South Texas Project Electric Generating Station P.O. Box 289 Wadsworth, Texas 77483

July 7, 2010
U7-C-STP-NRC-100162

South Texas Project
Units 3 and 4
Docket Nos. 52-012 and 52-013
Additional Information Regarding Draft Environmental Impact Statement

- Attachment 1. ER Figure 3.4-5
- Attachment 2. DEIS Figure 2-27

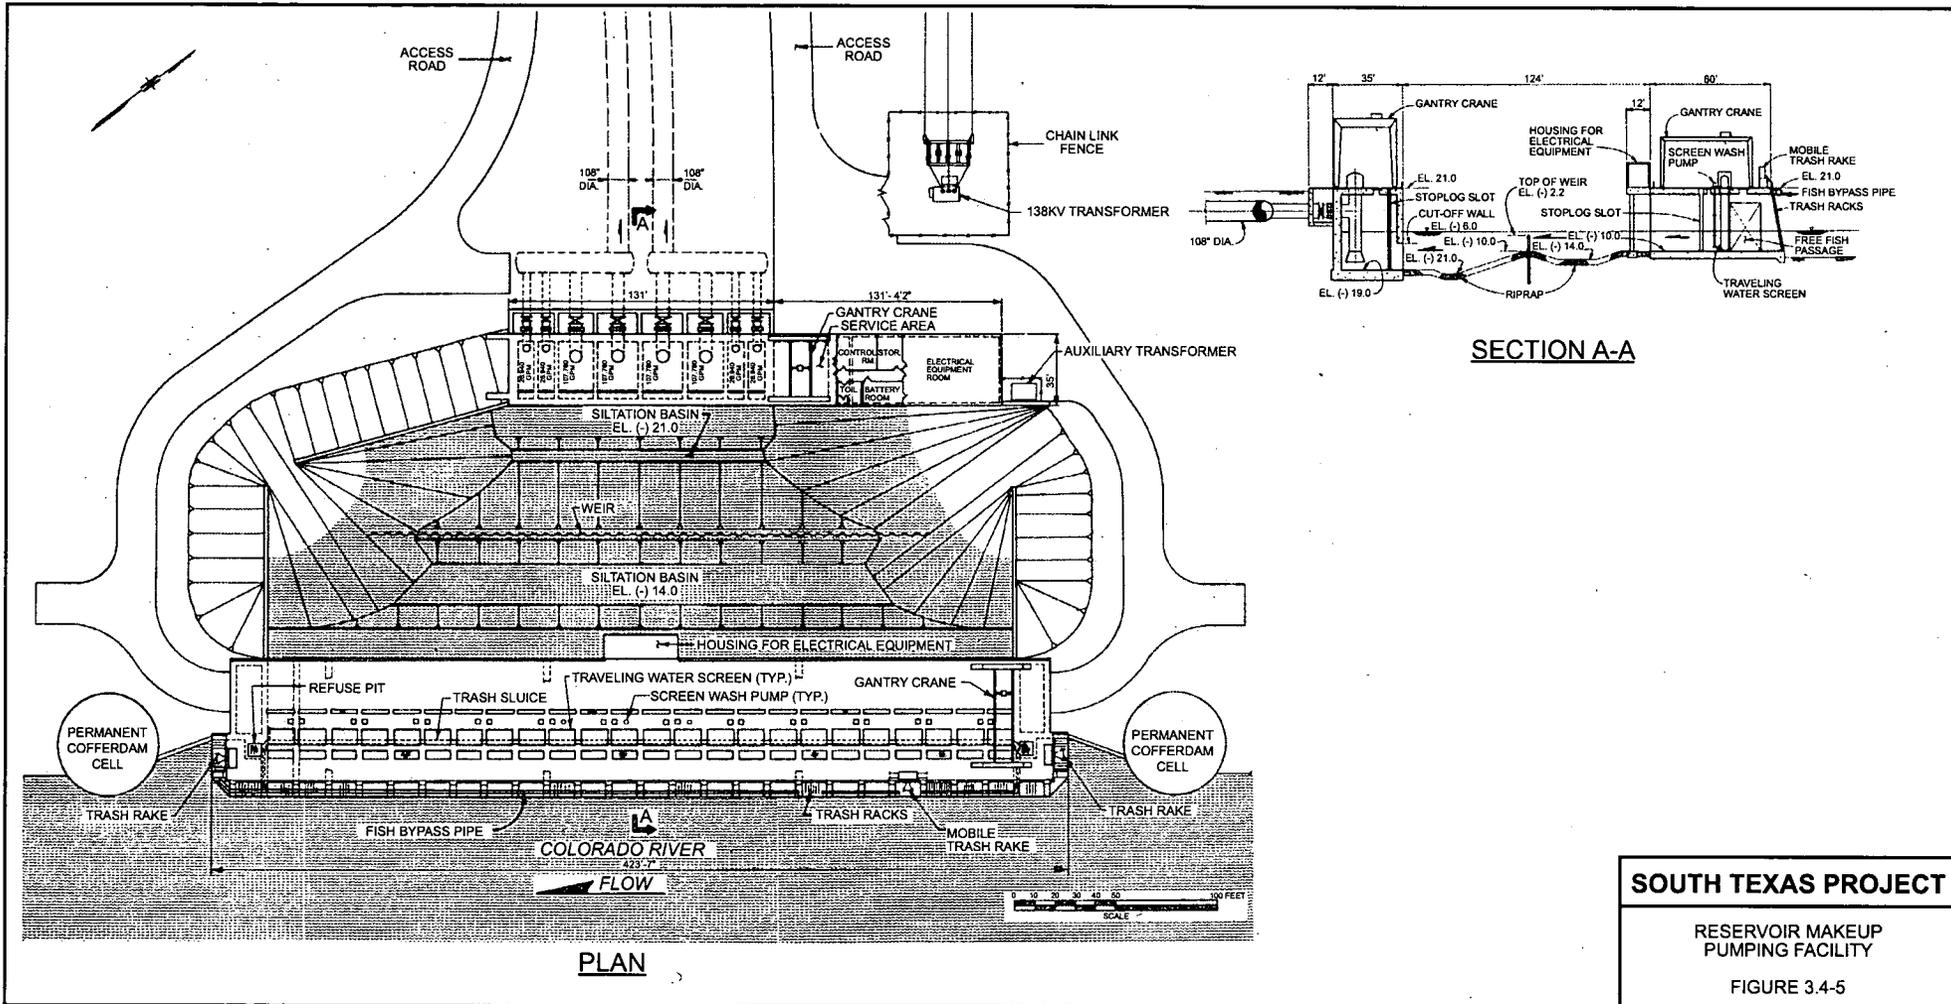
The reference letter contains STPNOC's comments on the (DEIS). Several comments referenced updated or corrected figures that STPNOC would submit for clarification. Attachment 1 contains a revised Environmental Report (ER) Figure 3.4-5 that is based on drawings contained in the STP Unit 1 and 2 Operating License ER. This updated figure will be included in the next Combined License Application (COLA) revision for Units 3 and 4. Submittal of this drawing supports the following STPNOC comments from the reference letter:

- Section 02.03.01, Page 2-19, Line 32
- Section 03.02, Page 3-6, Line 31
- Section 03.02, Page 3-7, Lines 1-2
- Section 05.02, Page 5-6, Line 37
- Appendix F, Page F-47, Line 16

Figure 2.5-21 Aggregate of Minorities Block Groups in the 50-Mile Region

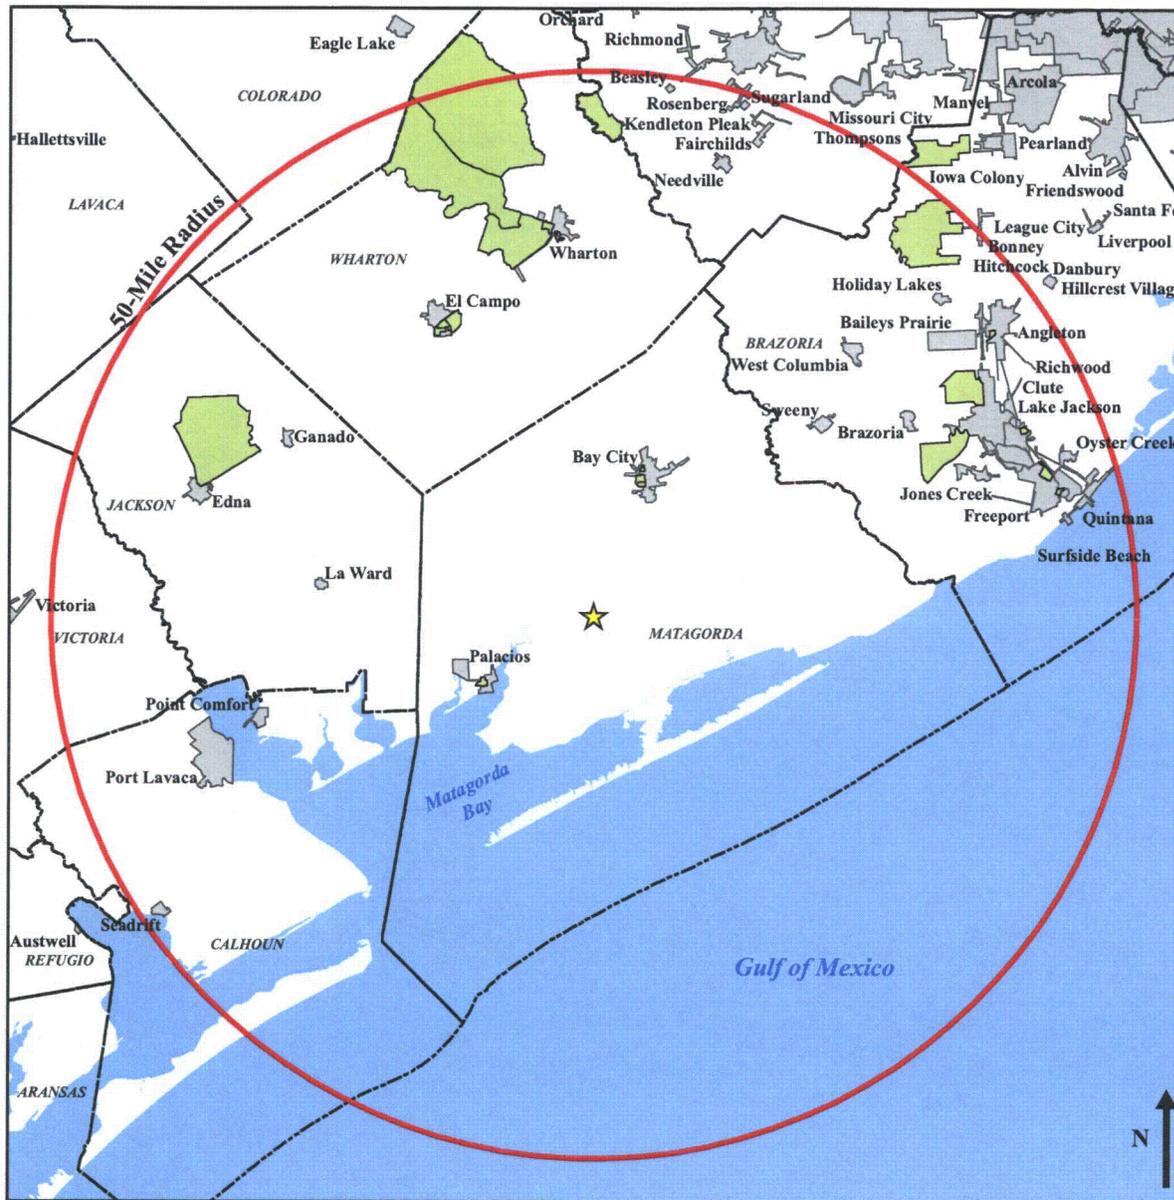
Attachment 2 contains the correct DEIS Figure 2-27. This figure supports the STPNOC comment in Section 02.06, Page 2-148, as discussed in the reference letter.
